South West Rocks

A report with respect to submissions to the
exhibition of the Environmental Assessment &
a Preferred Project Report with
updated Statement of Commitments

PLANNERS NORTH, May 2013

SETTLERS RIDGE, SOUTH WEST ROCKS

Plan 5.1 Connectivity Map

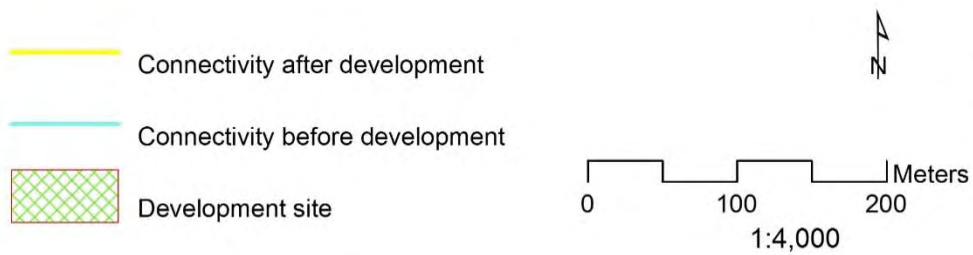
- The connectivity assessment appears to be correctly entered into the calculator, however, a map showing the corridors should be provided to explain how the assessment has been made.
- The vegetation zone area (the development footprint/impact area) is identified as 13.97ha. However, this figure has not considered the potential indirect impacts to the proposed open space area within the development footprint and the edge of the development to the retained vegetation to the west of the development footprint. It is clear that there will be some indirect impacts to these vegetated areas for the construction and operation of the proposed development.

The connectivity map is illustrated below in **Plan 5.1**.

Plan 8.1 Survey Effort Plan

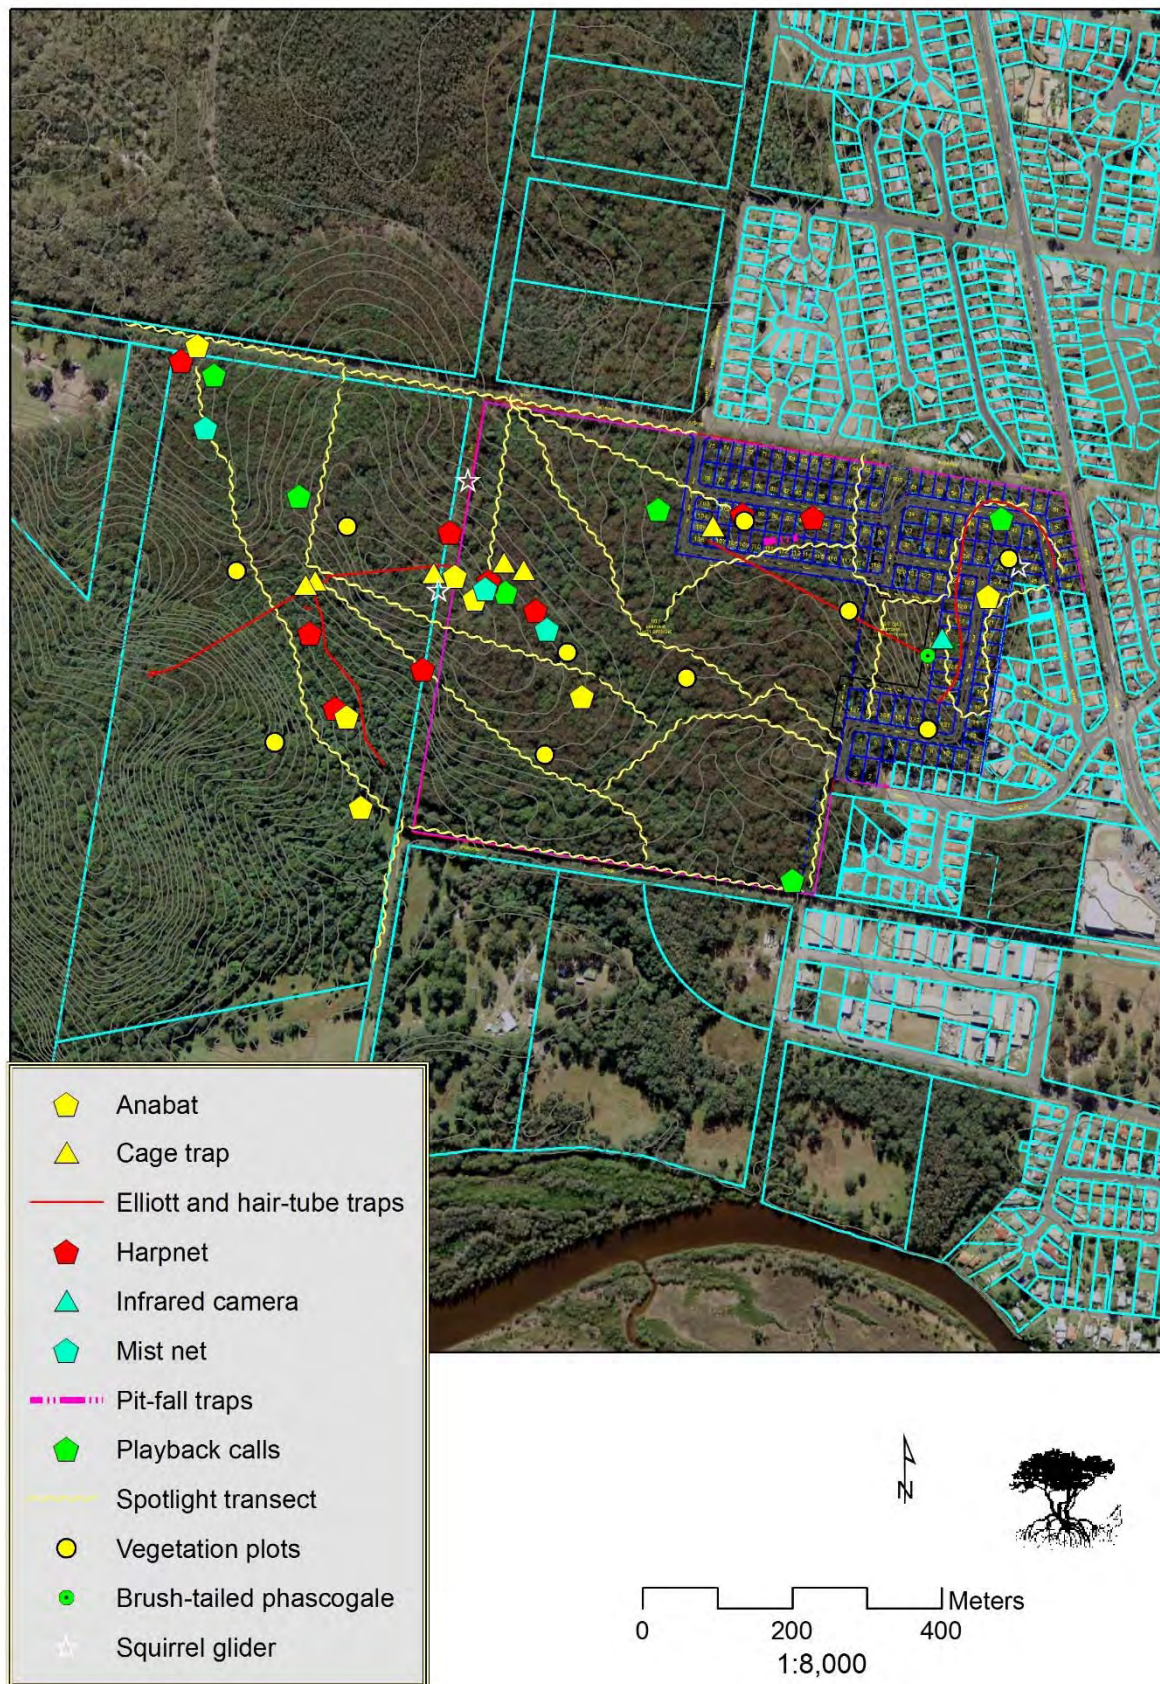
While the survey effort employed may generally be in keeping with OEH requirements, the survey locations within the site do not point to a comprehensive assessment of the fauna present. The survey locations (see Biodiversity Assessment Report, Figure 2) are largely clustered within a limited few areas of the site, which mostly do not correspond with the areas proposed to be developed. The clustering of the survey methods within these small areas may have affected the survey results, as only a small habitat area was sampled, thus reducing the potential for capture of fauna. The results obtained may not provide a representative indication of the fauna on the site in general or within the proposed development area specifically. The assessment does not provide adequate explanation of or justification for the proposed subdivision layout or development scale in terms of biodiversity impacts.

Although the site is recognised as being important for the resident threatened brush-tail phascogale, their location within the site is not disclosed within the reports (see Biodiversity Assessment Report, Figure 5 – Threatened Species records). This makes it difficult for the reader to assess the likely impacts to the population on site and the significance of those impacts. As the population has been detected within this and previous surveys, it is important to know where they occur and in what numbers. The fact that the phascogale is known to occur on site but was difficult to detect within this study may point to the limitations of the survey effort in capturing data on resident fauna populations, including this and other threatened species.

The conclusion that the survey locations do not point to a comprehensive assessment of the fauna present is not supportable on the evidence provided. Not only was the site comprehensively surveyed over various seasons and over various years, the adjoining land to the west was also included (see map below). That is the survey locations are not clustered and are do not exclude areas proposed for development. The survey results reflect this comprehensive survey effort, particularly when species recorded are compared to those recorded in previous surveys at or near the site. The brush tail phascogale was recorded in hair tube trapping and the location of these traps was illustrated in the Biodiversity Assessment report. Moreover, the BioBanking methodology has concluded that this species would occur over the whole of the development site making its precise location irrelevant. The credit report (in **Appendix B**) has identified the need to retire credits specifically for this species.

Plan 11.1
PREFERRED
PROJECT
137 LOTS

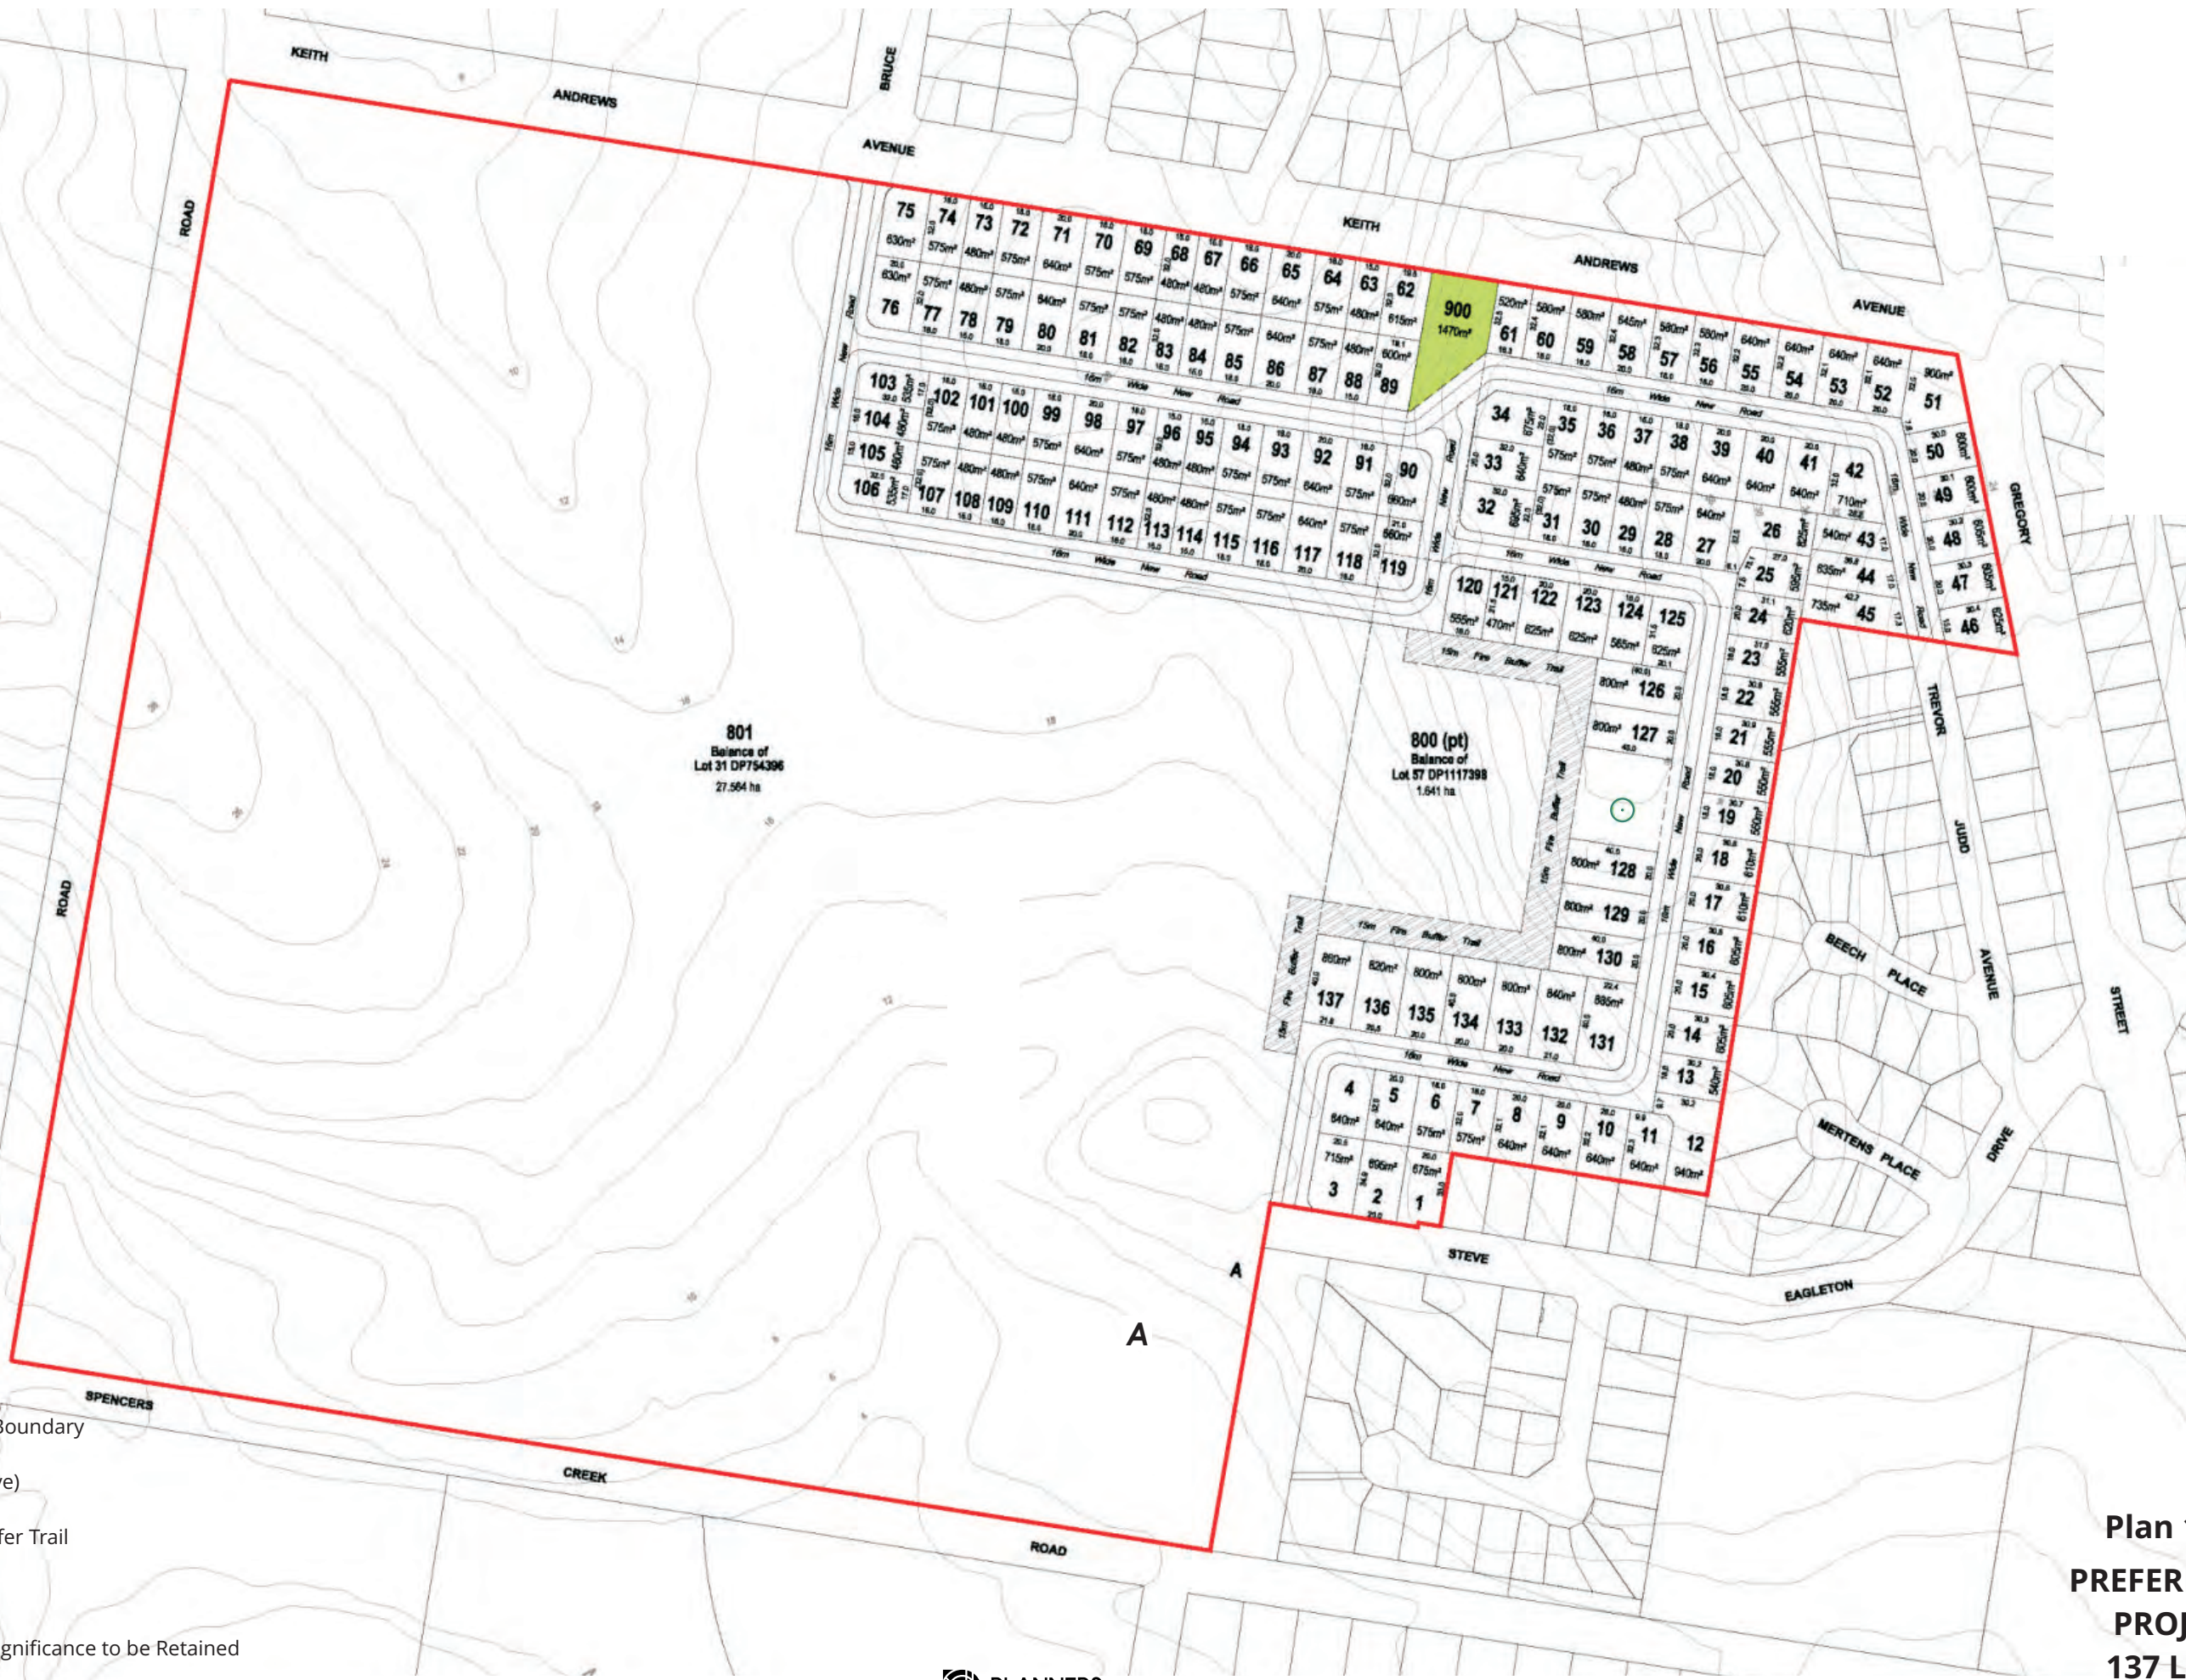
In respect to the points listed above, the department recommends the proponent consider a revised concept design that better responds to the existing threatened species habitat and provides improved vegetation connectivity. Revision of the concept design should aim to achieve the following outcomes:

- to avoid the fragmentation of land within proposed Lot 800, consideration should be made towards deleting the proposed extension of Steve Eagleton Drive (referred to as 'Future Road Reserve' on Plan 3.1) as part of the concept plan;
- consideration should be given to include Lot 800 as part of the proposed biobanking site to the south (Lot 801), or at the very least, the implementation of a long term management strategy for the protection of this land;

- 1 The applicant must prepare an alternative development layout that reduces the size of the development footprint and further avoids the impact to significant environmental values. Amendments to the layout should include reducing the western extent of the residential lots and deleting the proposed distributor road. The revised development layout should also aim to reduce the use of small open space areas for conservation purposes that have large edge effects and limited connectivity.

The proponent accepts the criticism of the exhibited EA scheme and its Preferred Project now involves no isolation or fragmentation of habitat as illustrated in **Plan 11.1**, with some 72.3% (29.2 hectares) of the site is now intended to be set aside in the balance lot and made available for BioBanking purposes. No segregation of portions of the site is now proposed and no extension of Steve Eagleton Drive is now contemplated.

The proponent, having regard to submissions received as a consequence of exhibition of the Environmental Assessment, has modified the concept plan with respect to the following aspects:

- The proposed extension of Steve Eagleton Drive has been deleted;
- Lot 800 and 801 in the EA subdivision plan have been amalgamated into a single balance lot available for BioBanking;
- A contiguous corridor has been created, eliminating the isolation of Lots 900 and 998;
- The subdivision footprint has been significantly reduced in size, and
- The scheme has been reduced from 154 residential lots to only 137 residential lots with the average lot size a generous 612 square metres in area.

Modifications to the site planning have been to have fulsome regard to the requirements by OEH. The changes to the plan are described at Section 11 of this report. Amendments to the layout include:
